Standard Stitches Ltd. Woven Unit (Extended Building)

FF TOWER, BAIMAIL, KONABARI, GAZIPUR SADAR, BANGLADESH
(24.008554, 90.330263)
9th February 2021

Building Information

1. Warehouse Building (G+9)

Plan of existing piles and pile caps

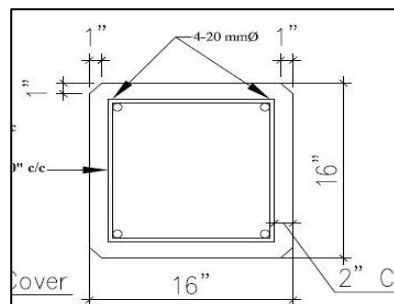
Factor of Safety of several pile foundations are below the allowable limit

As per the provided Detail Engineering Assessment report, factor of safety (FoS) of some piles are below the BNBC allowable limit for foundation.

Factory engineer is required to revise the floor load plan and propose remedial measure if requires for piles to reach the Factor of Safety above 2.50 in compliance with section 3.11.1.11 as per BNBC 2006.

Column Schedule

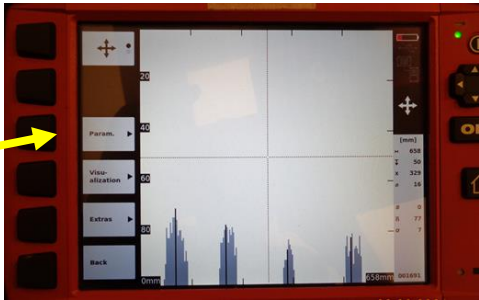
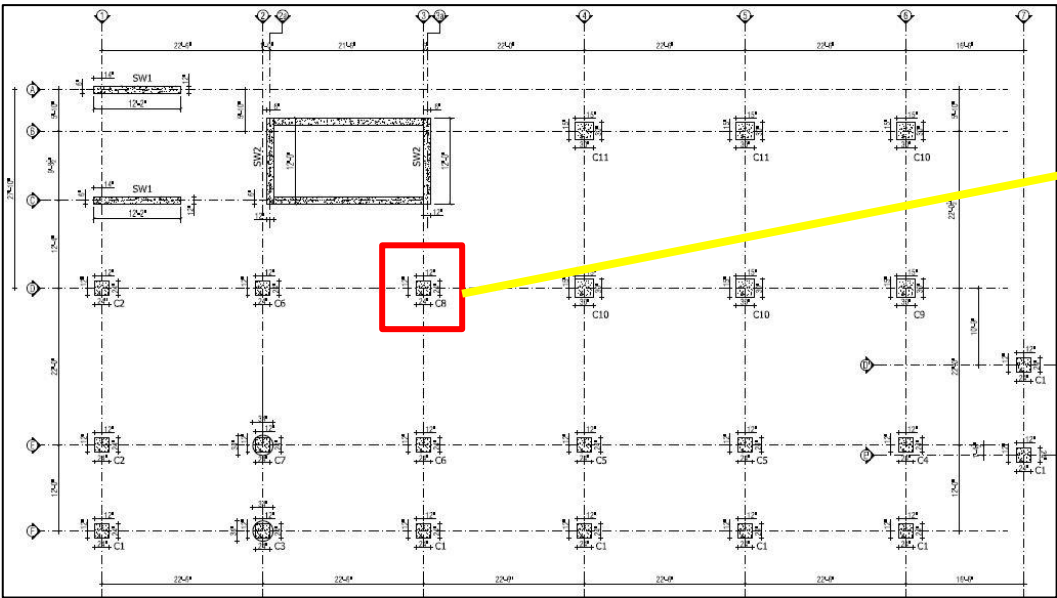
Column schedule in provided drawing demonstrating the columns only up to 5th floor but in reality, this building is ten storied.

In column schedule, 5 number of re-bar shown at each side for Column C8 (5th floor)

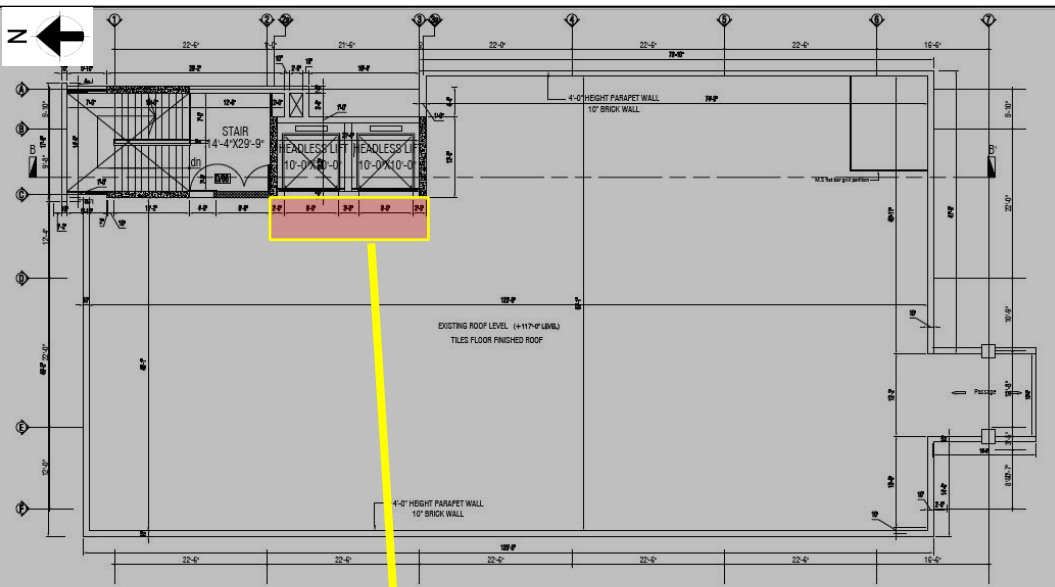
At 9th floor (Grid-D/3) the number of re-bar for column C8 was found 4 at one side by ferro-scanning. Therefore, variation in rebar inside the columns has been confirmed among the stories.

Factory engineer is required to survey the structures and prepare as-built drawings.

Roof Layout plan

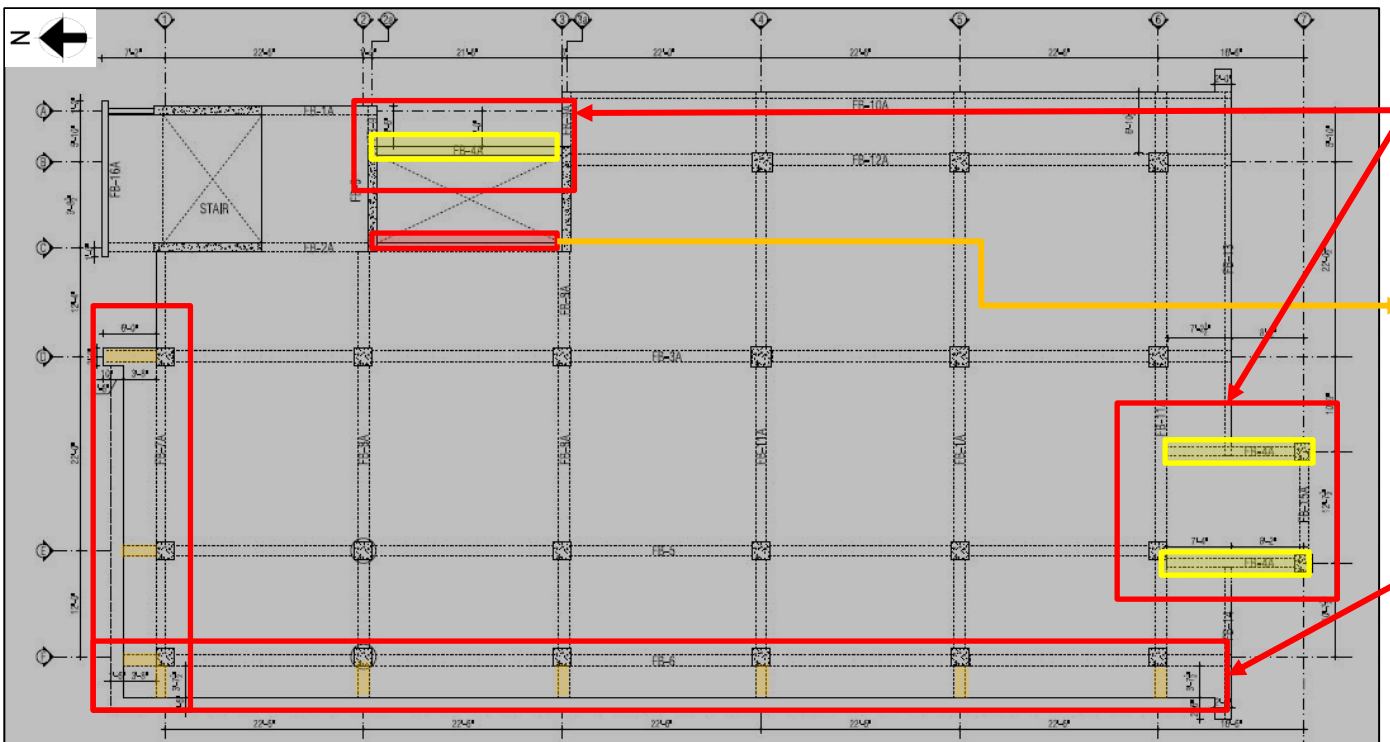
Interior of the lift machine room. Marked location is Cantilever.

Undocumented cantilever was found extended from the floor slab of lift machine room. No details was shown in drawing. Also, the details of the roof top beam & slab of lift machine room were not shown in as-built drawing.

Beam Layout plan

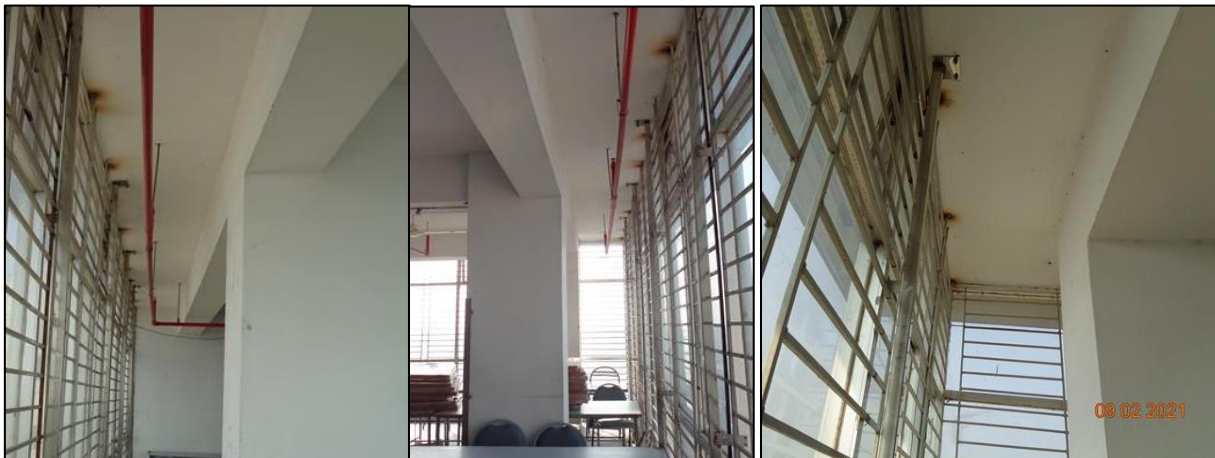
The details of the Beam (FB-4A) has not been provided in as-built drawing.

The Beam ID has not been written at the marked location.

These Cantilever Beam were not found at site but shown in as-built drawing.

Cantilever Beam not found at site

Factory engineer is required to survey the whole structure and prepare accurate as-built drawings that are compliance with section 1.9.1.2 as per BNBC (Part-06).

Hairline cracks in beam

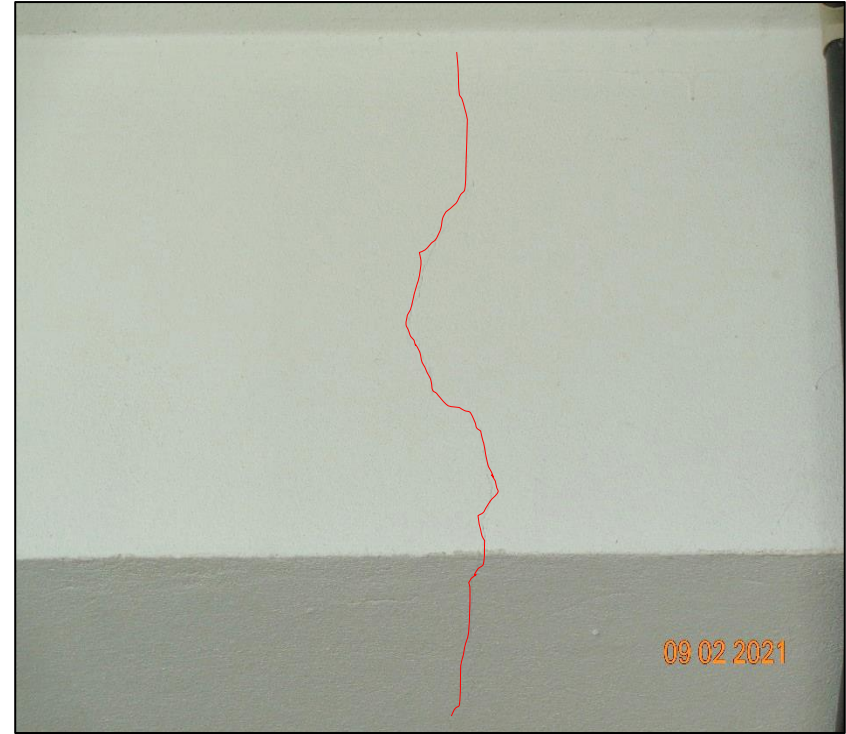
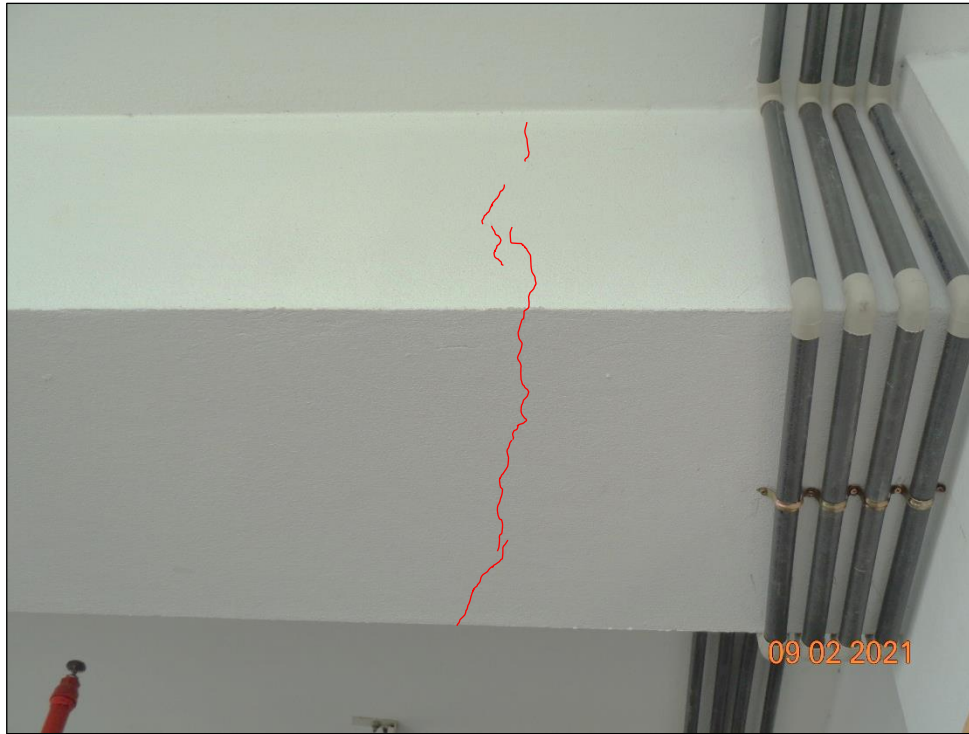
Hairline crack in beams

Hairline crack was found in the several beams throughout the building. Factory engineer is required to investigate the cause of crack and repair the cracks as per investigation report.
